Local Planning Panel

Address: 349 Liverpool Street, Darlinghurst

Application Number: D/2022/831

Recommendation

Height

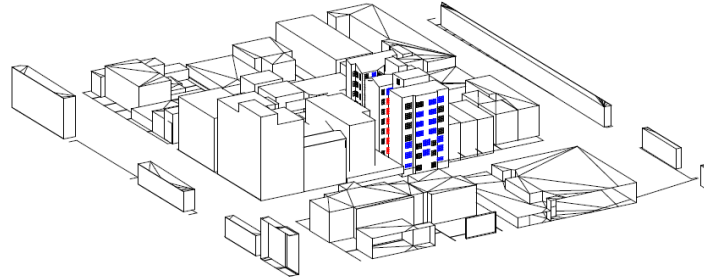
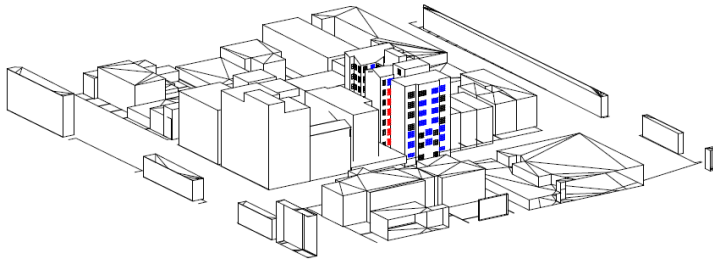
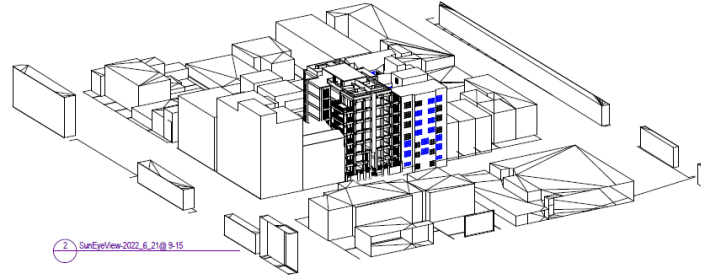
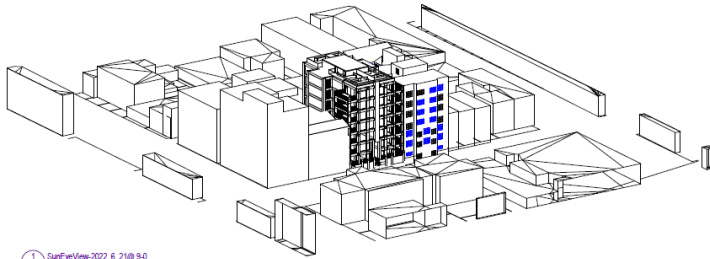
- non-compliant height, storey height and street frontage height
- Clause 4.6 not supported due to heritage, overshadowing and view impacts

Overshadowing

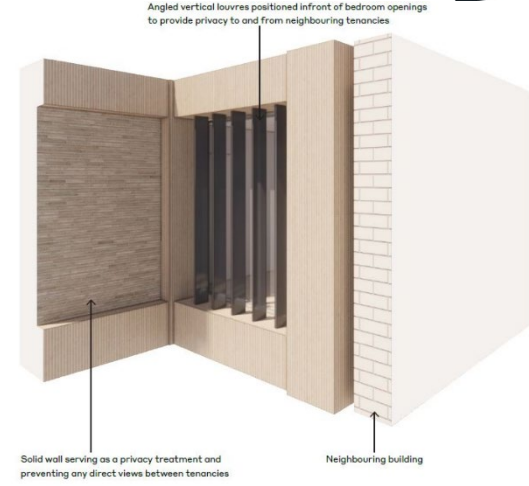
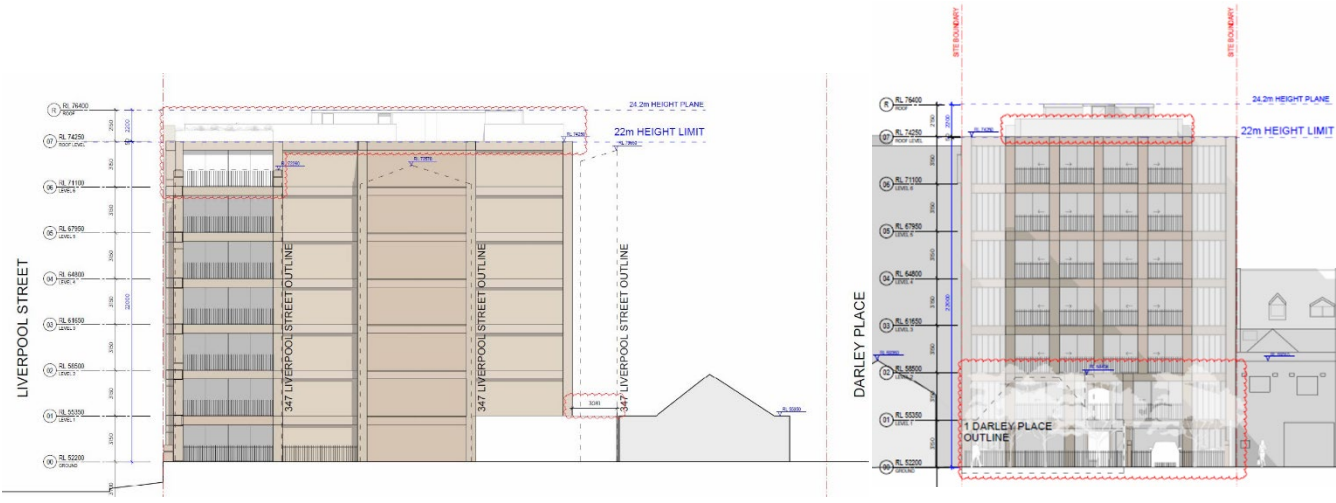
- overshadowing from building elements exceeding height controls
- insufficient survey detail and sun's eye view detail

Building separation and visual privacy

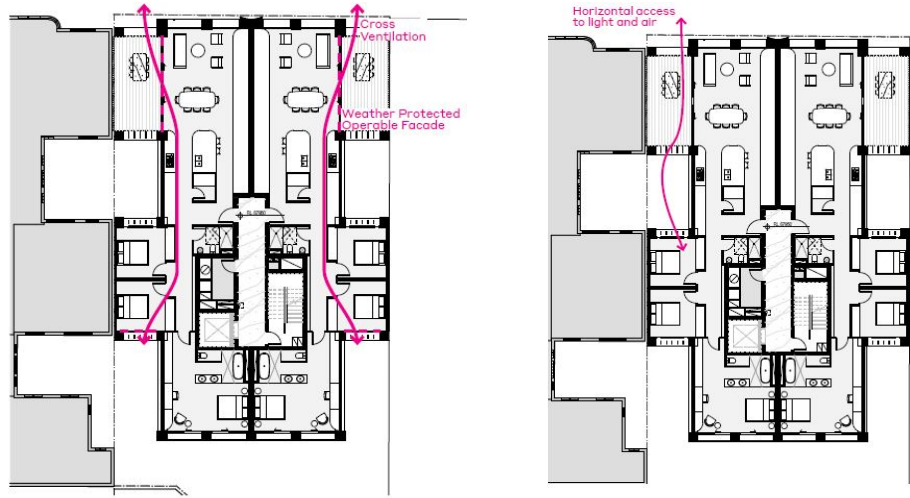
- non-compliant building separation and overlooking
- insufficient detail on privacy measures

Natural ventilation and acoustic privacy

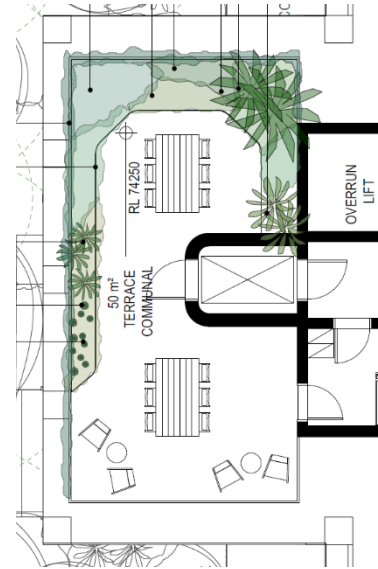
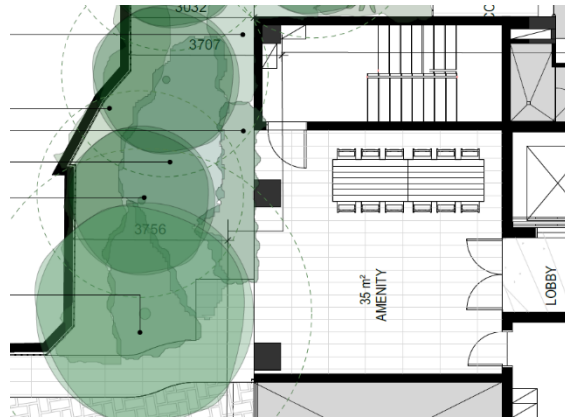
- non-compliant apartment depth
- reliance on lightwells for access to natural ventilation to habitable rooms
- acoustic privacy mitigation reduces access to natural ventilation

Communal open space

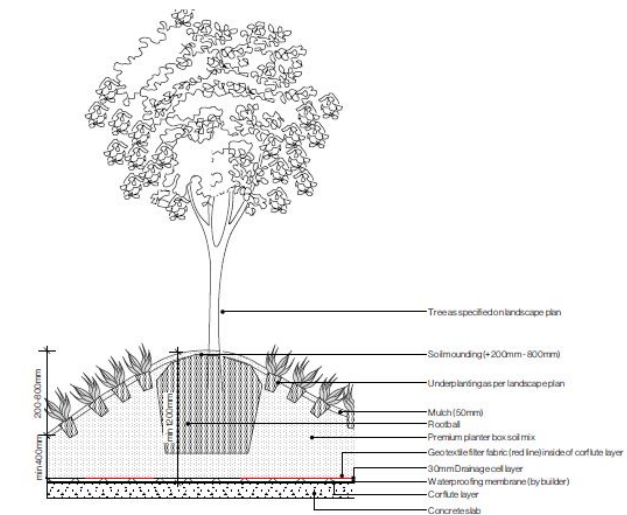
- non-compliant communal open space area and dimensions
- no solar access to ground floor common open space
- inadequate design e.g. no shade structures, insufficient amenities

4 Mounded garden bed detail Ground Level Courtyards
Scale: 1:25

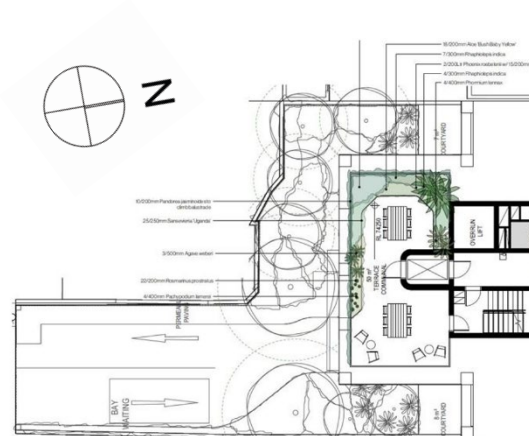
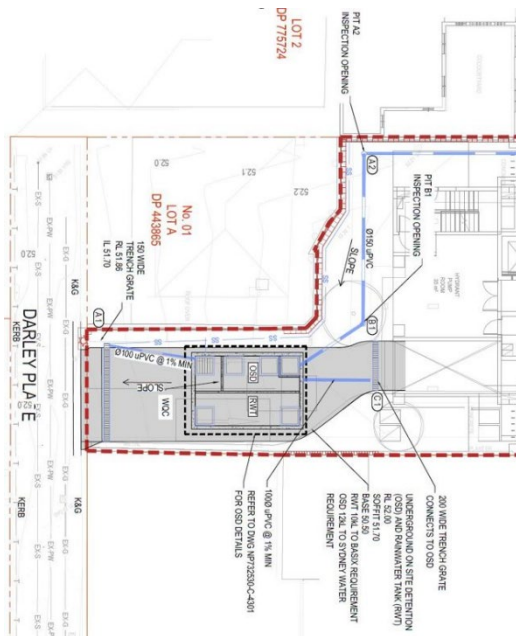
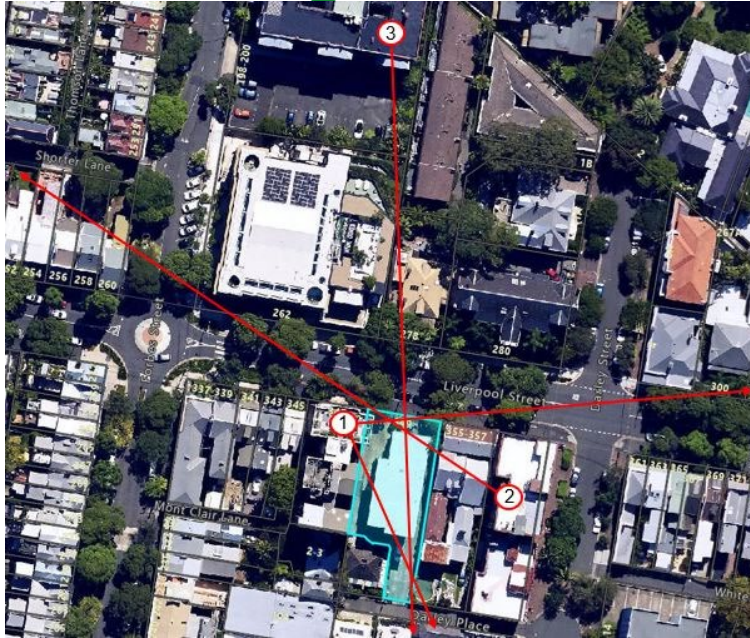
- excessive soil mounding and insufficient soil depth
- non-compliant deep soil area and tree plantings conflict with stormwater pipe
